**ADDENDUM NO. 1
TO THE
SPECIFICATIONS AND CONTRACT DOCUMENTS**

City Project No. FAC23008O

City Hall Generator

November 24th, 2025

Project No: **23196**

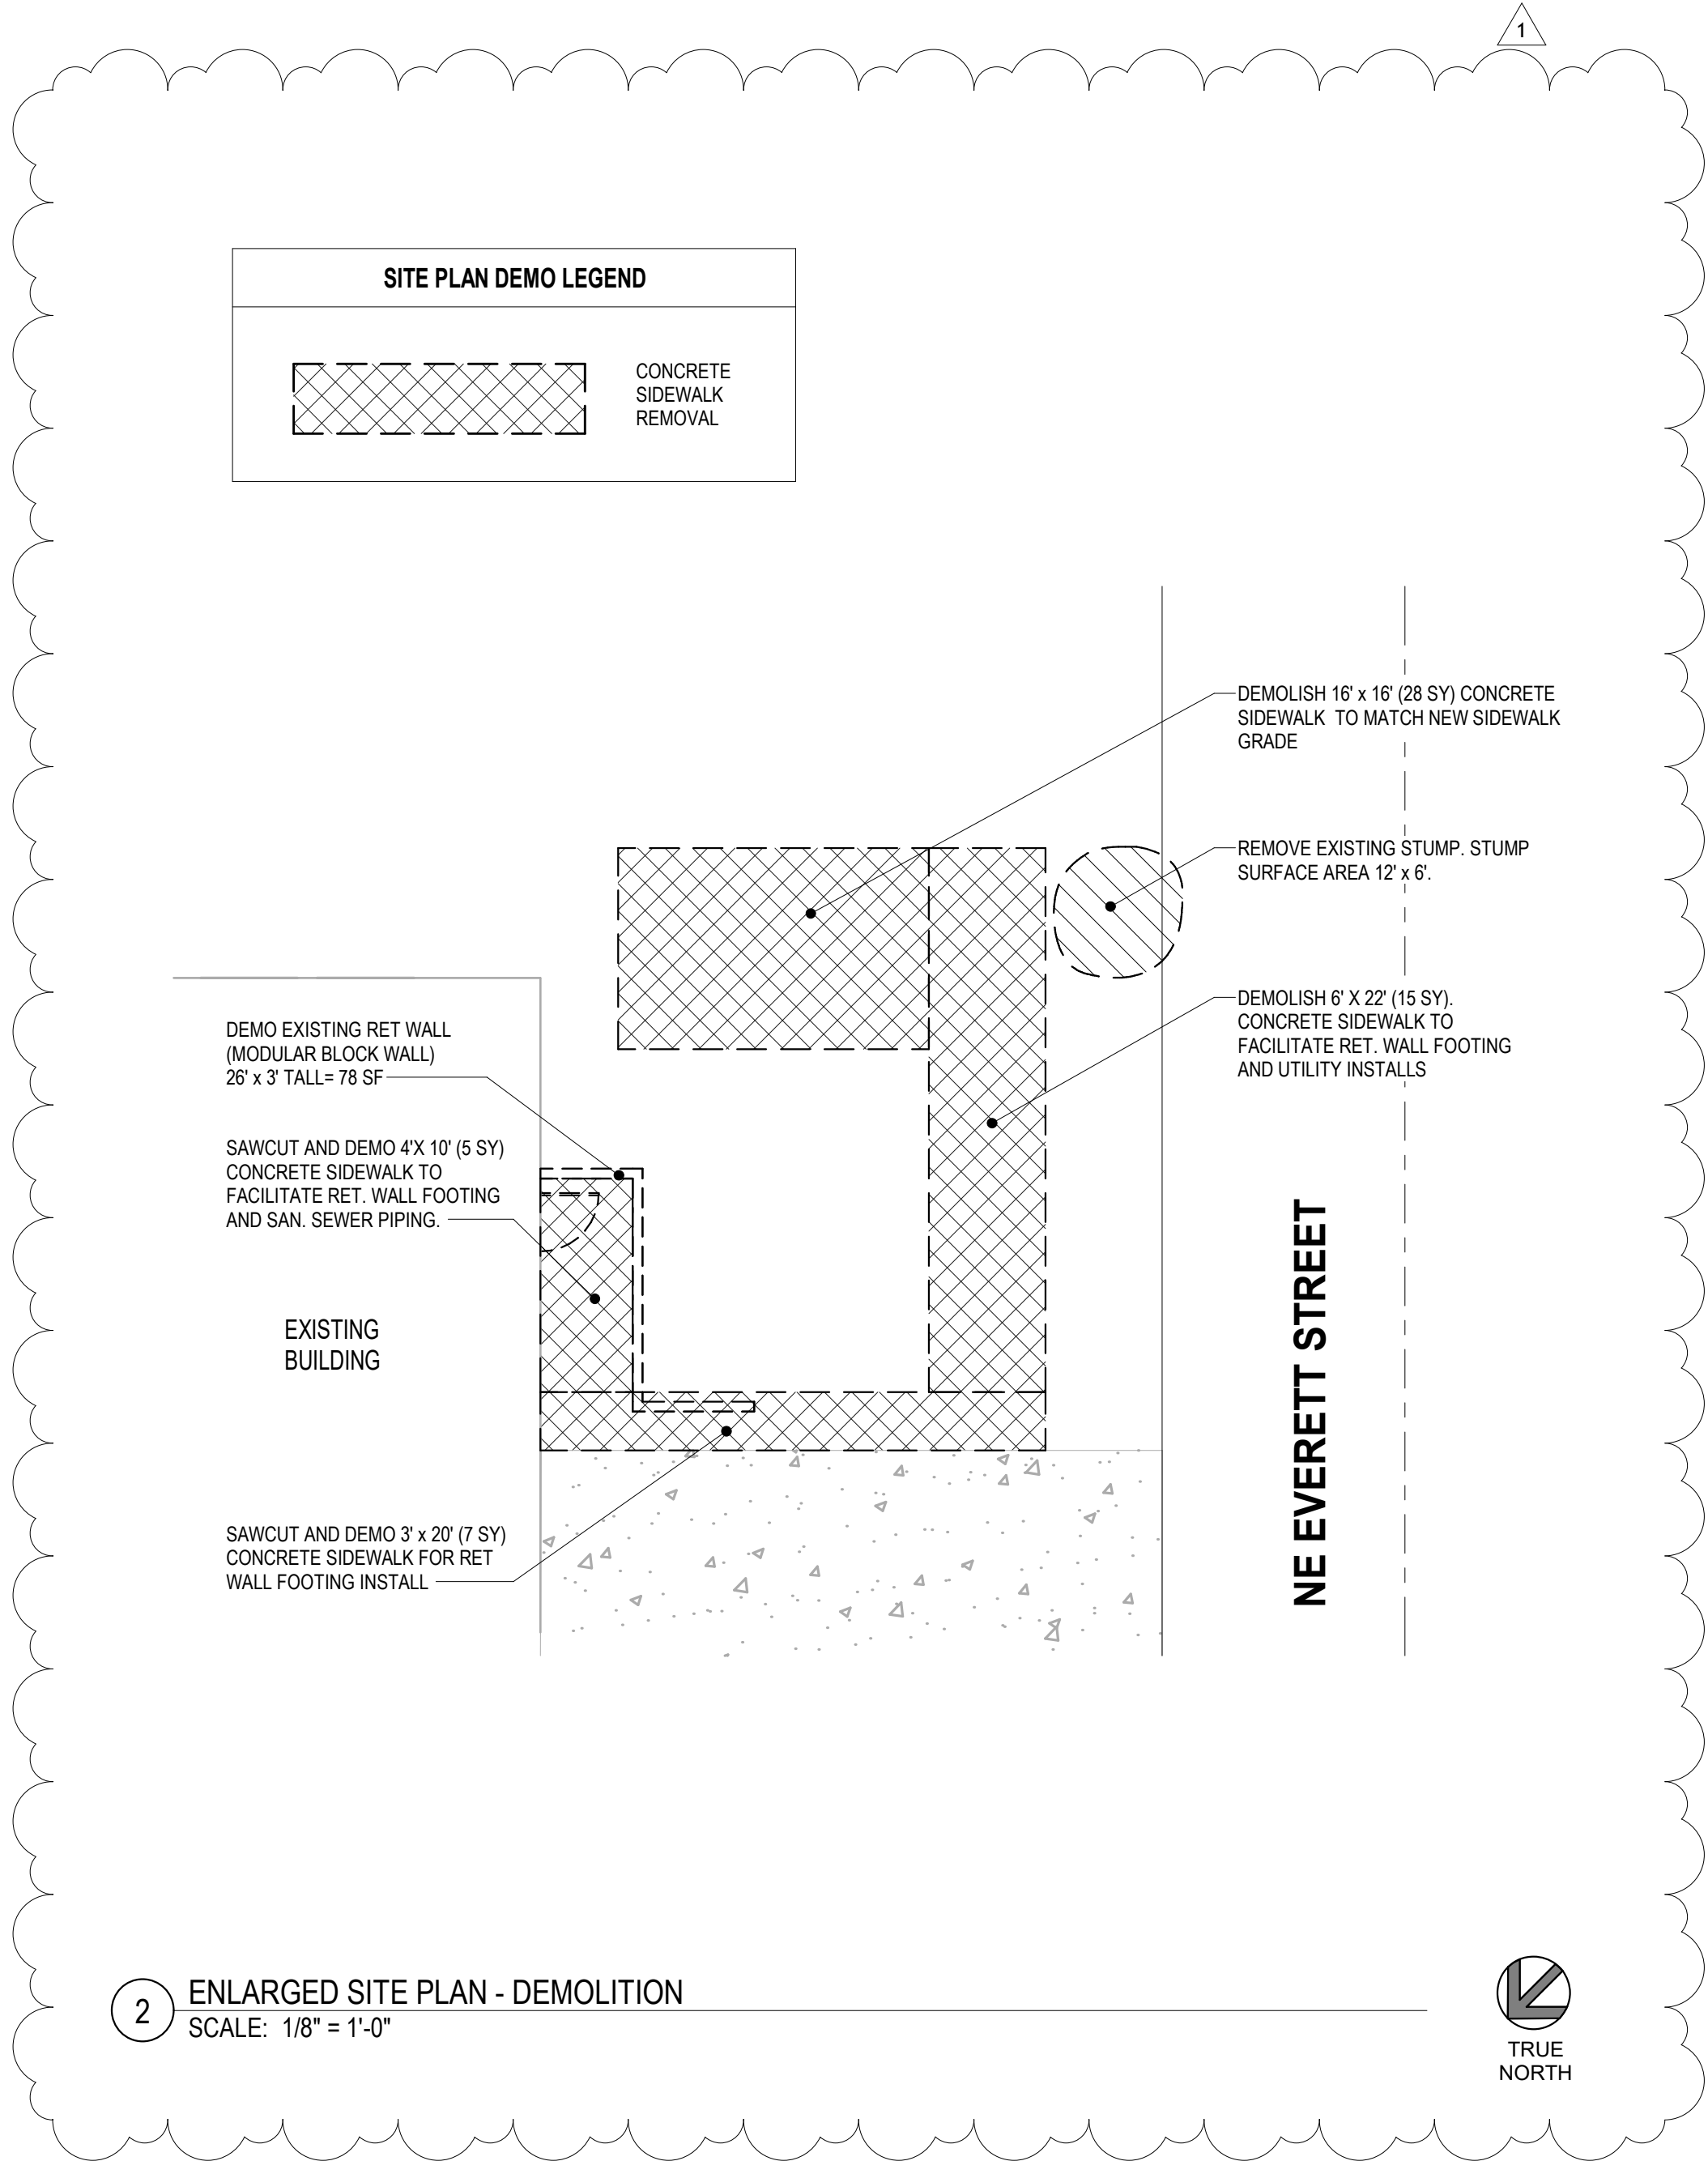
Electrical Scope: The underground utility vault between Clark Public Utilities (CPU) existing power pole and existing CPU meter location has been revised. There will be no Clark Public Utilities involvement on this project. See revised electrical plan sheets.

Electrical Plan Sheets E100 and E601

Delete plan sheet E100 and E601 in their entirety and replace with revised plan sheets.
See attach plan sheet E100 and E60.

A010

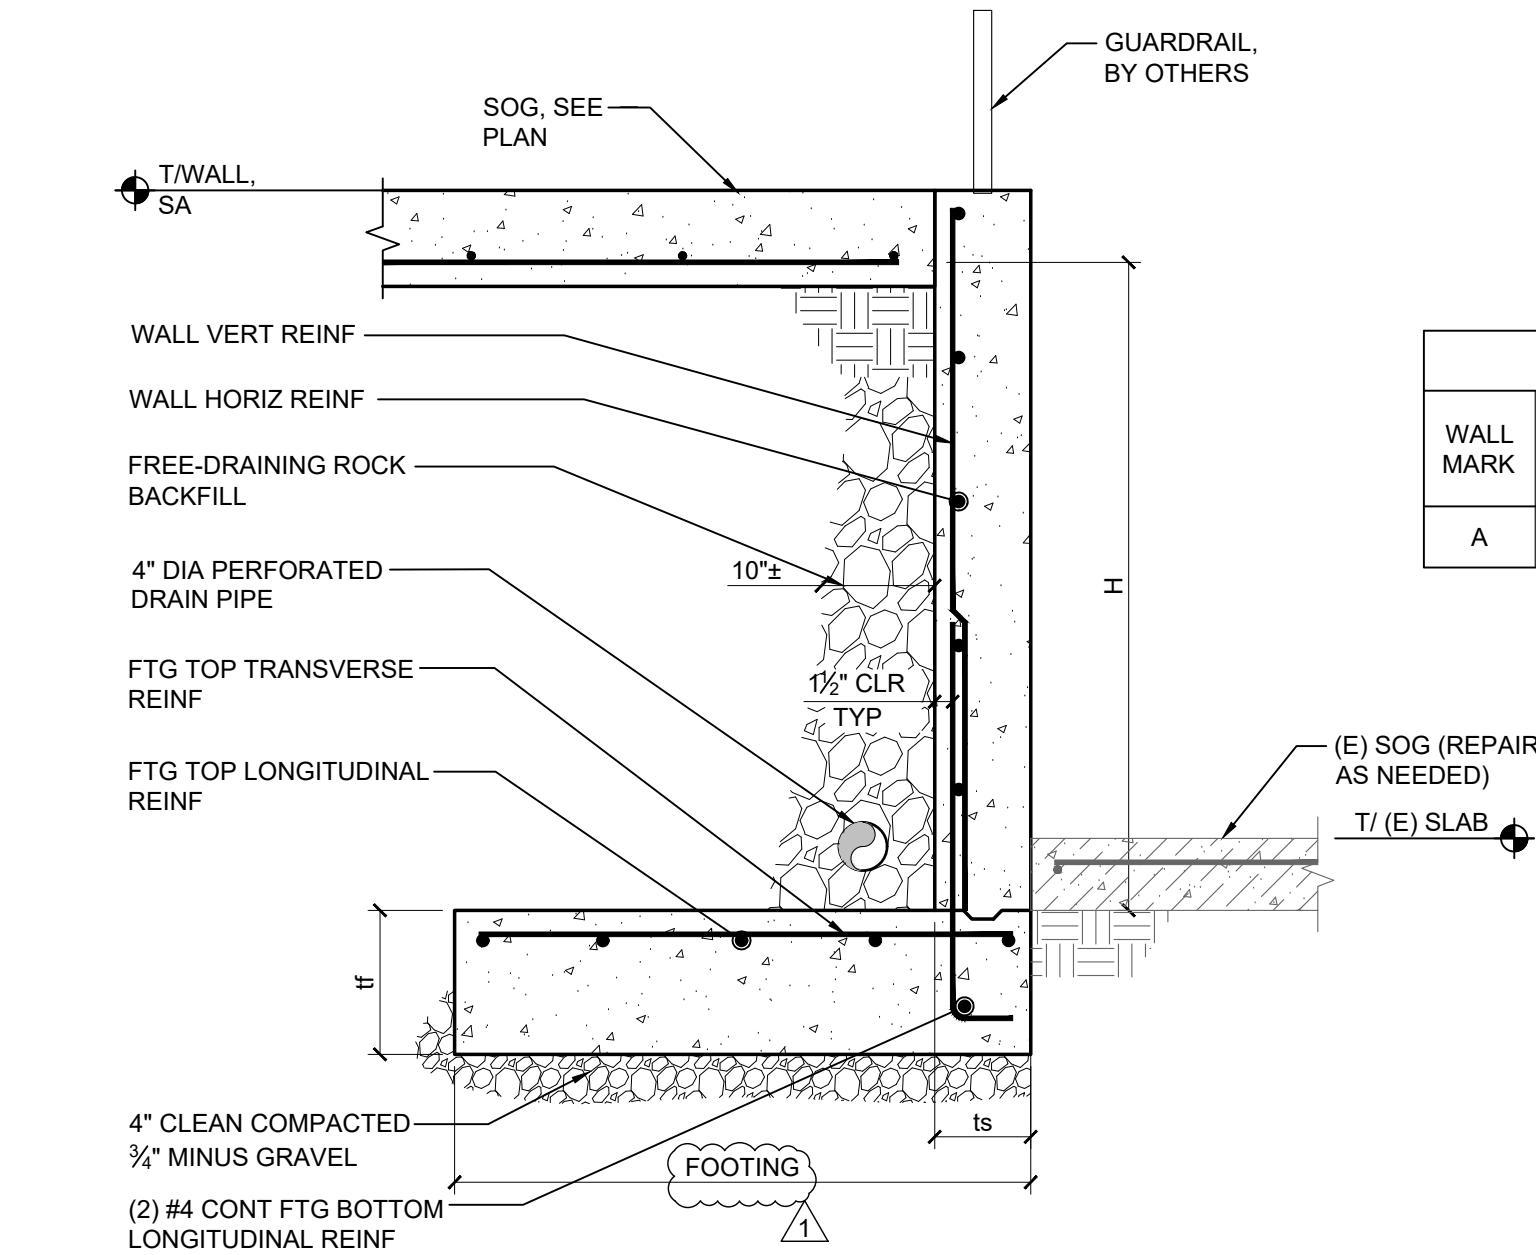
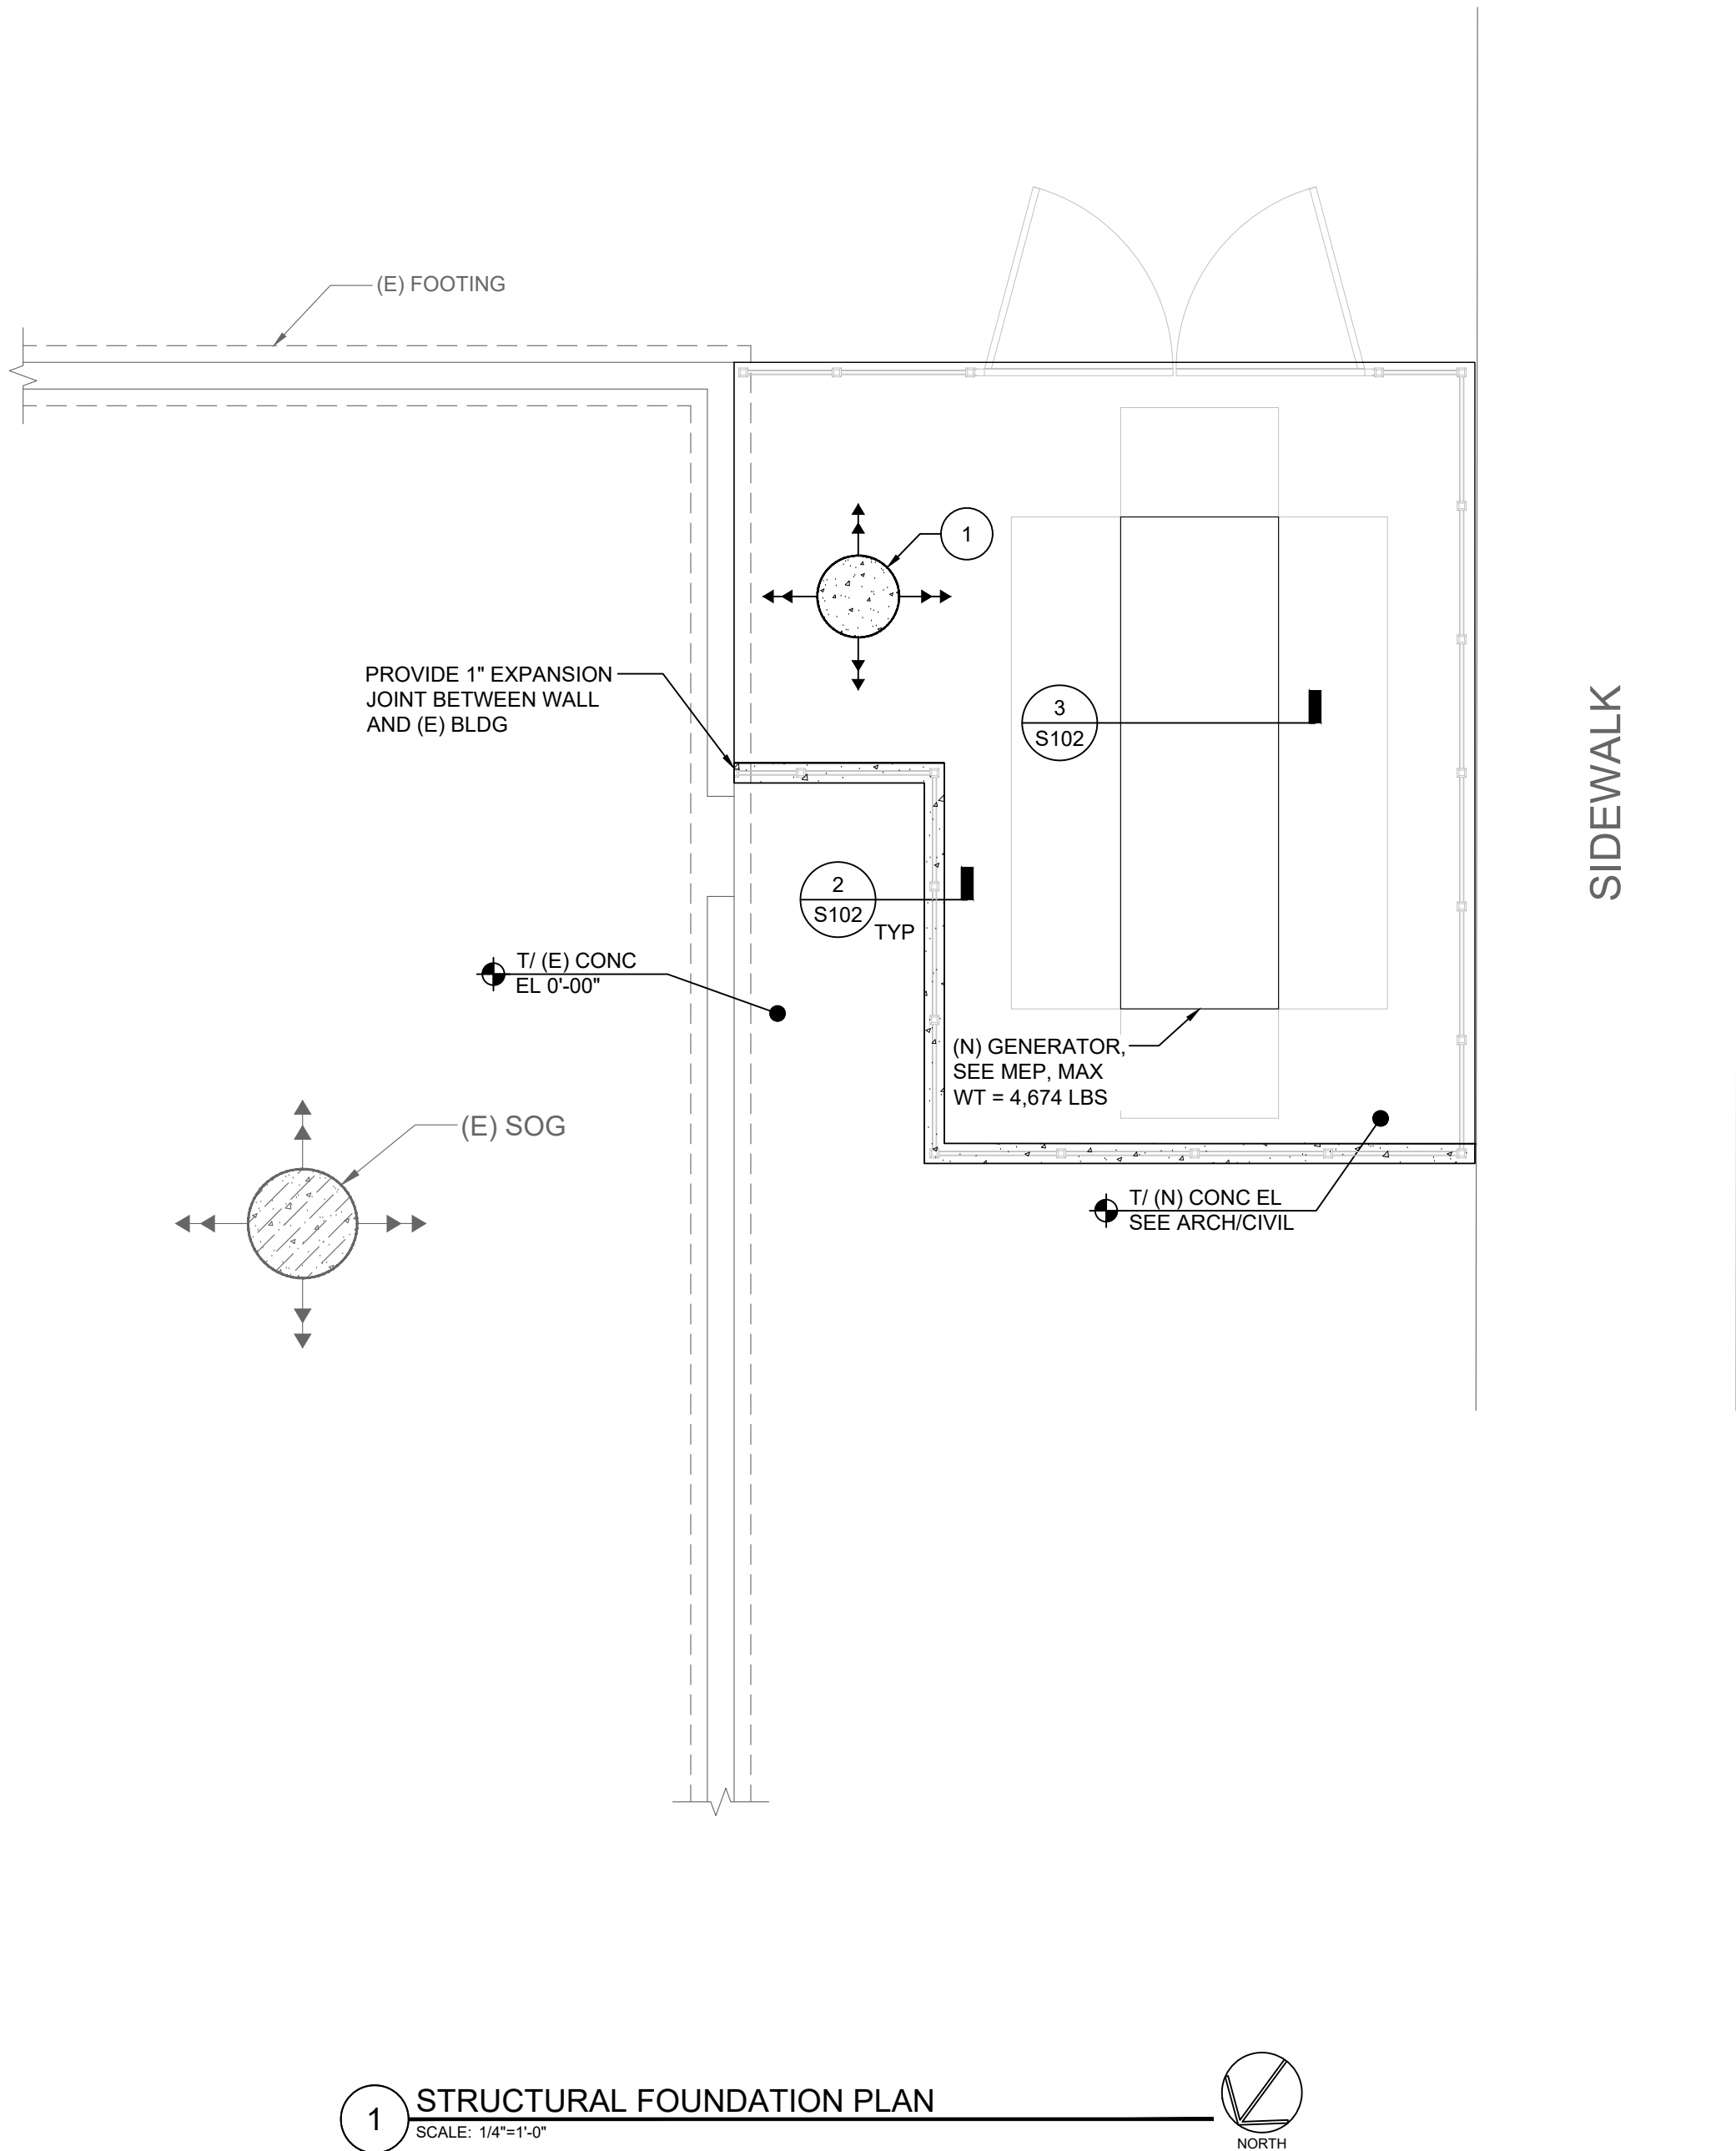
Site Demolition Scope: Additional detail provided on architectural plans regarding site preparation demolition items and job quantities for removal for existing retaining wall, concrete, and stump. All demolition items to be removed from site and become property of contractor. See revised Architectural plan sheet.

Architectural Plan Sheets A010

Delete plan sheet A010 in its entirety and replace with revised plan sheet.
See attached plan sheets A010.

- REPLACE CONCRETE SIDEWALK PER CITY OF CAMAS DETAIL ST18P103. SIDEWALK GRADE TO MATCH THE SURROUNDING WORK HAPPENING IN THIS AREA. FINAL GRADE TO BE CONFIRMED WITH THE CITY OF CAMAS PRIOR TO COMPLETING WORK PER CITY OF CAMAS. PER CITY OF CAMAS PROVIDE APPROXIMATELY 28 CY. OF CONCRETE.
